Work Order ID 92848

Item Name: Crosstube Fwd High

DART AEROSPACE LTD HAWKESBURY, ONTARIO, CANADA	
DRAWING NO. D212-664-141	REV. D SHEET 1 OF 4
TITLE XTUBE ASS'Y (205/212/412 HI FWD)	SCALE NTS
COPYRIGHT © 2010 BY DART AEROSPACE LTD THIS DOCUMENT IS PRIVATE AND CONFIDENTIAL AND IS SUPPLIED ON THE EXPRESS CONDITION THAT IT IS NOT TO BE USED FOR ANY PURPOSE OR COPIED OR COMMUNICATED TO ANY OTHER PERSON WITHOUT WRITTEN PERMISSION FROM DART AEROSPACE LTD.

DRAWING NO. D212-664-141	TITLE XTUBE ASSY (205/212/412 HI FWD)	REV. D	DART AEROSPACE LTD ENGINEERING ORDER		D.E.O. NO. D212-664-141-D-1	SHEET NO. SHEET 1 OF 2	SCALE NTS
DRAWN	CHECKED <i>UP</i>	MFG. APPR. <i>R</i>	APPROVED <i>NA</i>	DE APPR. <i>HA</i>			
DATE 11.04.07	DATE 11.07.11	DATE 11.04.12	DATE 11/04/12	DATE 11.04.12

D212-664-141/-141B  
ASSEMBLY DETAIL

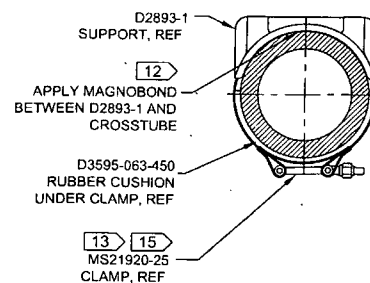
**PURPOSE:**  
REPLACE MAGNOBOND WITH PROSEAL.

NOTE 12 & 15, SHEET 1 IS AMENDED AS FOLLOWS:

- 12) TO INSTALL D2893-1 SUPPORT: ABRASE MATING SURFACE OF SUPPORT AND CROSSTUBE WITH 180-GRIT SANDPAPER AND REMOVE RESIDUE WITH MEK (OR EQUIVALENT). APPLY A 0.04" TO 0.07" THICK LAYER OF PROSEAL 890 CLASS B-2 (OR AMS-S-8802 CLASS B-2) SEALANT TO MATING SURFACE OF SUPPORT.
- 15) TORQUE CLAMPS 80 TO 100 IN-LB. ENSURE AT LEAST 1.5 THREADS SHOWING IN SAFETY AND THAT NUT HAS NOT BOTTOMED-OUT AFTER TORQUING. **PRIOR TO PACKAGING, RE-CHECK TORQUE ON CLAMPS AFTER PROSEAL 890 SEALANT HAS CURED FOR 72 HOURS.**

**D212-664-141/-141B  
ASSEMBLY DETAIL**

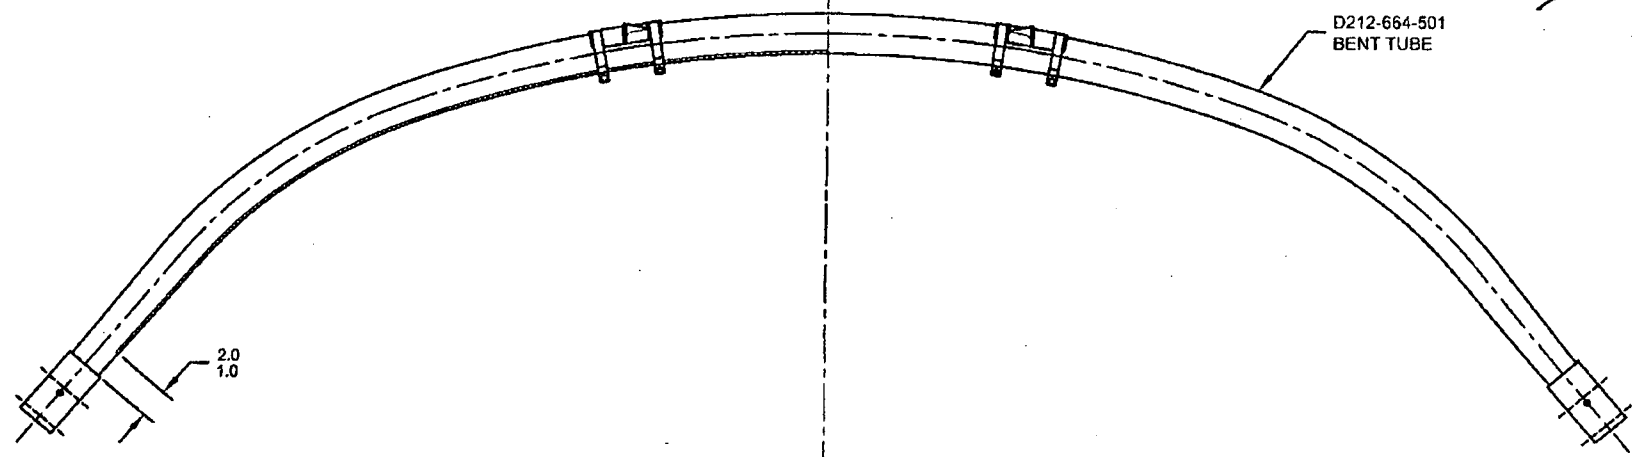
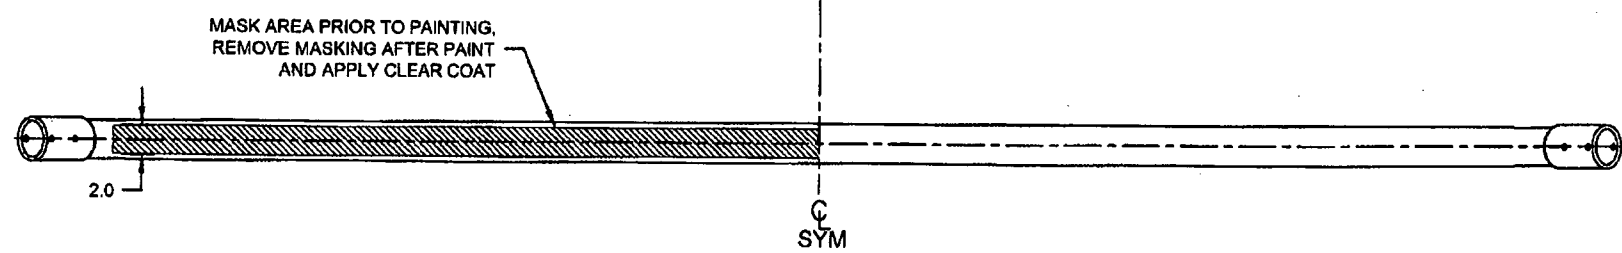
ADD AN INSPECTION WINDOW TO UNDERSIDE OF CROSSTUBE.

NOTES 2 OF SHEET 1 IS AMENDED AS FOLLOWS:

- 2) FINISH: CHEMICAL CONVERSION COAT PER DART QSI 005 4.1  
PRIME INSIDE AND OUTSIDE PER DART QSI 005 4.2  
MASK UNDERSIDE OF CROSSTUBE AS SHOWN (HATCHED AREA) AND  
PAINT OUTSIDE PER DART QSI 005 4.2  
REMOVE MASKING AND APPLY CLEAR COAT

IS:

WAS:
